MODIFICATION REQUEST:
***Concept Plan for the Riverwood North
Estate Residential Renewal Project
Kentucky Road and Washington Avenue,
Riverwood
(MP 10_0167 MOD 3)***

***Increase to height of building envelopes, total
dwelling numbers and total gross floor area for
Phase 02 (Stage 2 and 3)***

Secretary's Environmental Assessment Report
Section 75W of the *Environmental Planning and
Assessment Act 1979*

October 2014

Figure 6: Proposed envelopes for Phase 02 (Stage 2 and 3)

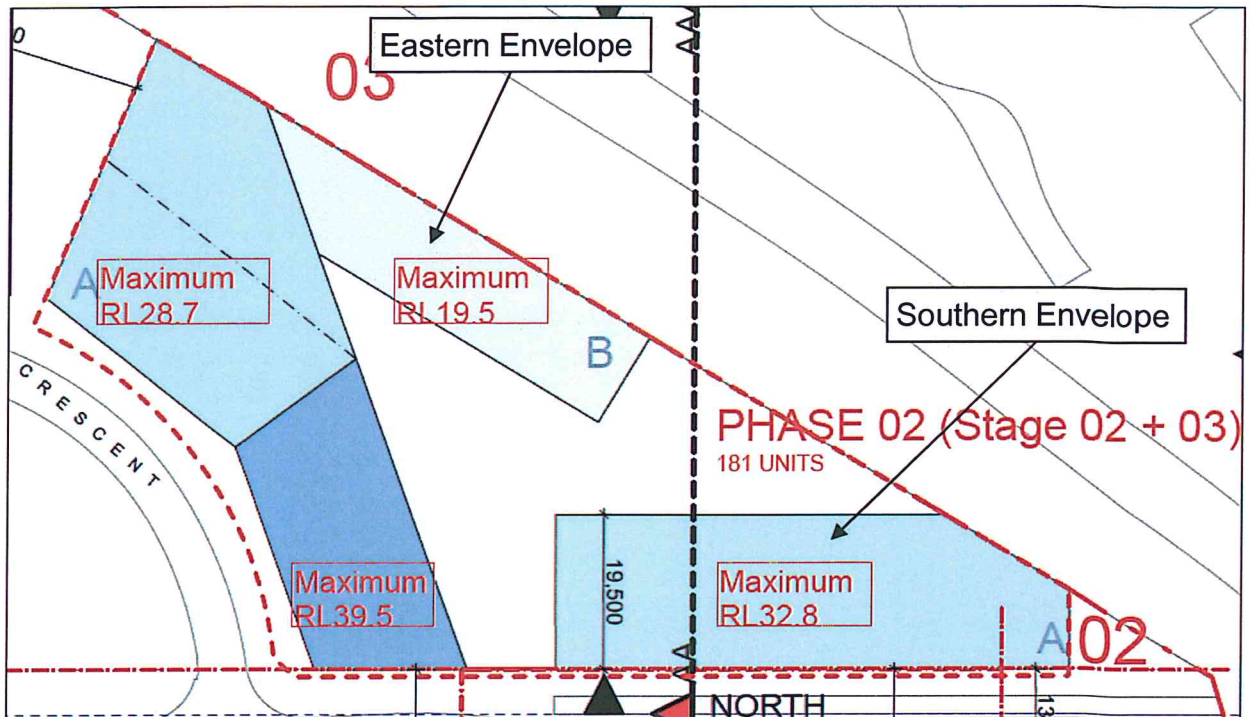
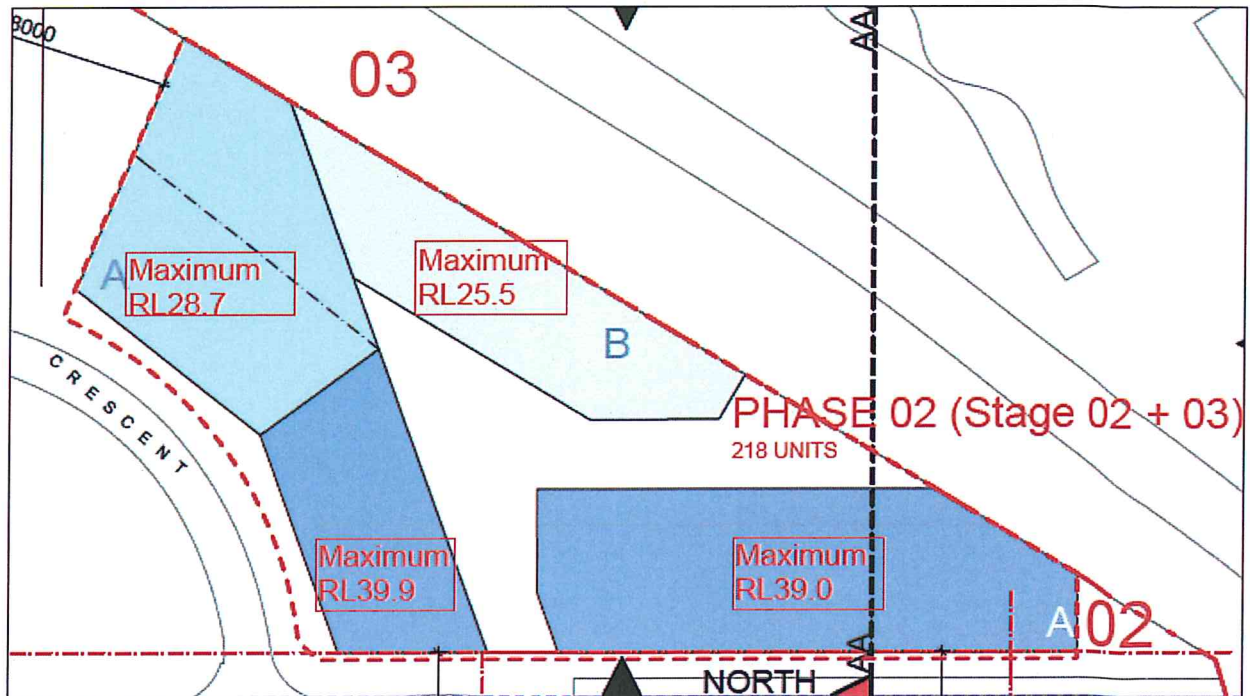
The proponent seeks to modify the building envelopes by increasing the building envelope height of the Eastern Envelope and Southern Envelope by up to two storeys (approximately 6.0 m) (see **Figure 6**), increasing the permissible floorspace from 15,901 sqm (FSR 3.0:1) to 19,690 sqm (FSR 3.77:1), and making minor amendments to the envelope footprint to better

The proposed minor amendments to the building footprints of the Eastern and Southern Envelopes result in decreases to the building separation distances, as follows:

- 11.5 m to 8.475 m between the Eastern Envelope B and Southern Envelope A; and
- 12.0 m to 9.1 m between the Eastern Envelope A and Southern Envelope A.

The Department is satisfied that the increased height of the building envelopes would have acceptable built form impacts as:

- the bulk and scale of the building envelopes are consistent with the surrounding built form and higher density urban character already established for the area;

- the height of the proposed building envelopes would be equal to or lower than the taller nine storey envelopes and 10 storey envelope within the concept plan site;

- the highest building envelopes are positioned on the southern portion of each block, which optimises amenity for future residents;
- the northern envelope continues to be significantly lower than the remainder of the concept plan to provide a transition to Salt Pan Creek Reserve; and

Figure 7: Approved mixed use development partly located on Phase 01 Building C site (see Figure 3)

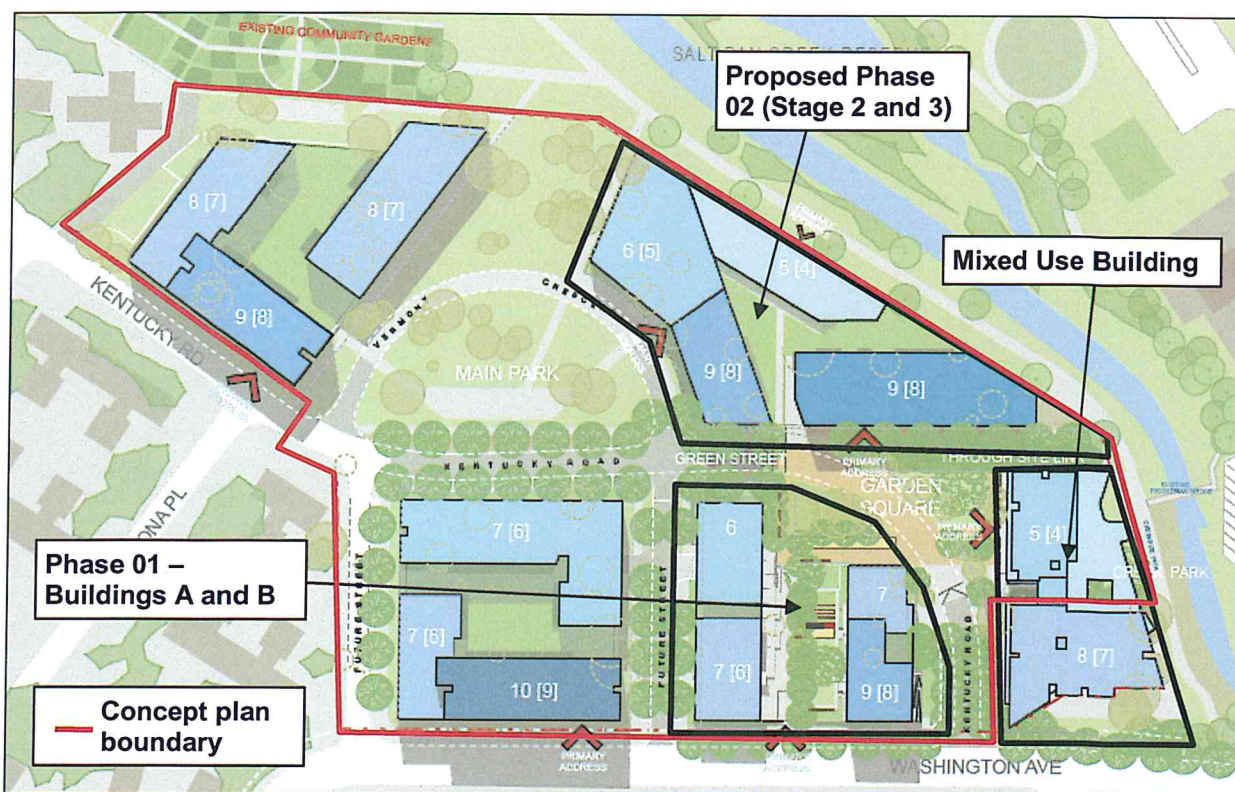
- the proposed increase of the Phase 02 (Stage 2 and 3) south-eastern building envelope from seven to nine storeys is comparable with the increased scale of the eight storey mixed use development to the south of the concept plan, approved by the Sydney East Joint Regional Planning Panel (see **Figure 7**).

Figure 8: Overshadowing from the proposed Phase 02 (Stage 2 and 3) envelopes during mid-winter at 9 am

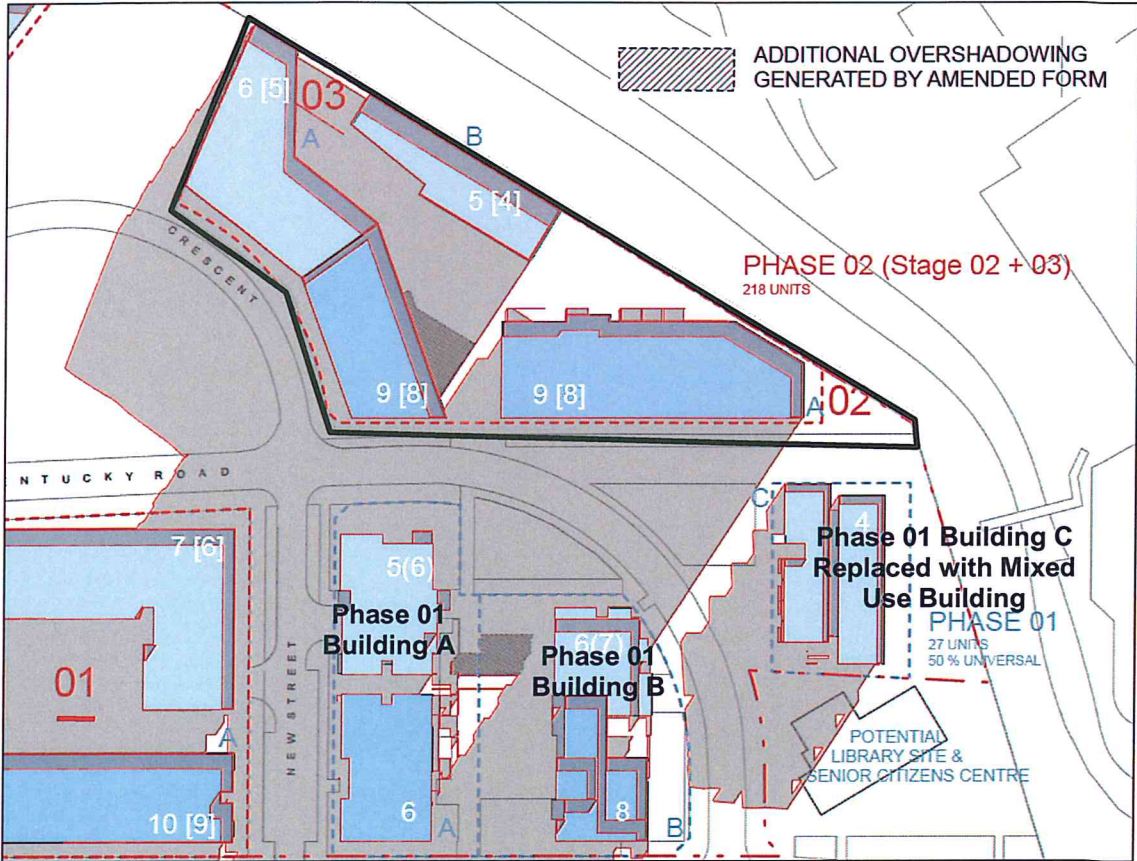
The two storey increase in height of the southern building envelope would create additional overshadowing on the completed social housing units in Phase 01 (Stage 1) and the mixed use building. In addition, the increased height of the northern component of the eastern envelope would overshadow units within the same building envelope to the south (see Figures 8 to 10).

The overshadowing from the additional two storeys on the southern envelopes would reduce solar access to the north eastern units within Phase 01 Building A and B. The proponent has advised that whilst the north-eastern apartments within Building A on the ground floor and upper ground floor and north facing units on the lower levels of Building B would encounter additional overshadowing they would still retain two hours of solar access in mid-winter in high density areas. The modifications would also result in three units of the mixed use development losing the minimum two hours of solar access required during mid-winter, however, the proponent has indicated that the overall number of dwellings receiving a minimum two hours of solar access during mid-winter would meet the 70 per cent recommended in the RFDC.

Council raised no issues with the level of overshadowing. The Department notes that the additional overshadowing would fall on the northern units and north-eastern units of Phase 01 Building A and northern units of Phase 01 Building B. The overshadowing would be restricted to the early morning and the additional overshadowing would generally be for less than 30 minutes for the affected units. The units to be affected by the additional overshadowing also receive solar access in the afternoon due to the northerly orientation and would therefore all retain the minimum two hours of solar access required during mid-winter. Accordingly, the overshadowing of these units would not reduce solar access below acceptable amenity criteria. The redesigned mixed use building that replaces the approved Building C has a significantly higher number of units that are able to receive the two hours of solar access during mid-winter and therefore the increased overshadowing would not reduce solar access to below the acceptable amenity criteria.

The Department concludes that the overshadowing impacts from the two additional storeys for both the envelopes is acceptable as the additional overshadowing is contained to within the concept plan area and the buildings to be impacted would maintain appropriate levels of solar access.

Figure 9: Overshadowing from the proposed Phase 02 (Stage 2 and 3) envelopes during mid-winter at midday

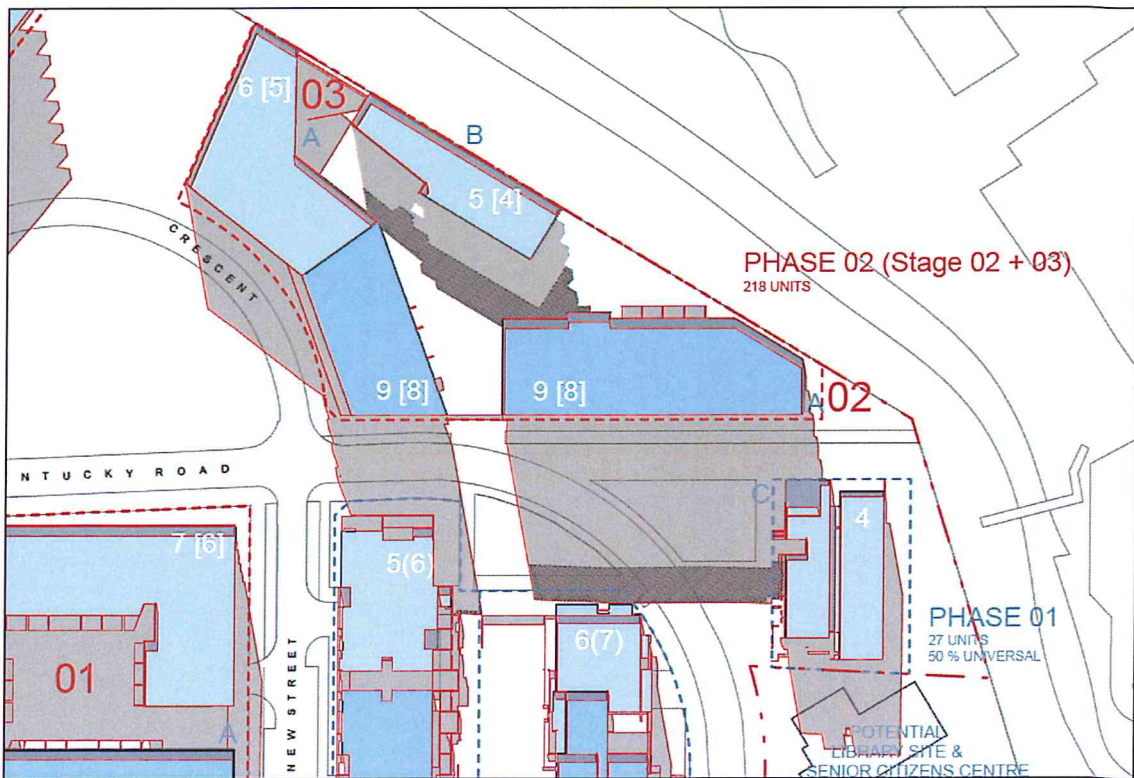
The increase in height of the southern envelope would also further overshadow Garden Square at 12 noon during mid-winter, resulting in an approximate 25 per cent increase in overshadowing. Notwithstanding, the current design already results in substantial overshadowing of this open space area (see **Figure 9**), with the additional overshadowing predominantly limited to hard landscaped/pedestrian access areas and generally no additional overshadowing projected to soft landscaped areas.
